Technical Change

1775620000	ZPE 1.5/4AN	1608670000	ZPE 6
1775510000	ZPE 1.5	1775560000	ZPE 1.5/3AN
1791150000	ZDK 1.5PE	1791010000	ZDK 2.5-2PE
1808330000	ZPE 2.5 S	1772090000	ZPE 2.5-2
1706090000	ZPE 2.5-2/3AN	1706100000	ZPE 2.5-2/4AN
8671050000	ZDK 4-2 PE	1815080000	ZTPE 2.5/2AN/1
1815140000	ZTPE 2.5/4AN/4	1815170000	ZDT 2.5/2 PE
1712810000	ZPEB 2.5-2	1808210000	ZPEA 2.5-2N

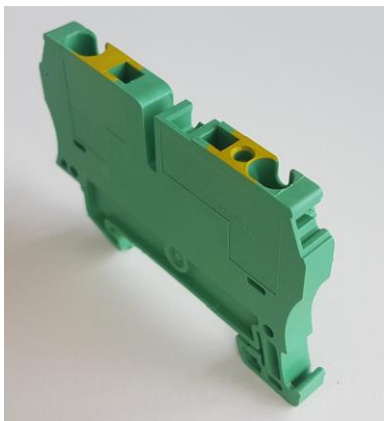
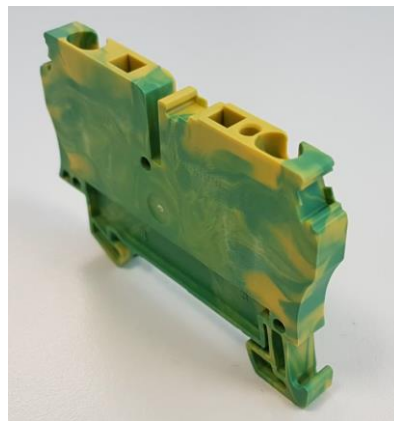
At the moment, the affected terminal blocks are made in green plastic material and get a yellow printing afterwards.

In the future the affected products will be manufactured in a marbled design, as shown in the following pictures.

- Unification of products
- Recognisability of the PE terminals

The change will be implemented in Q2/2021.
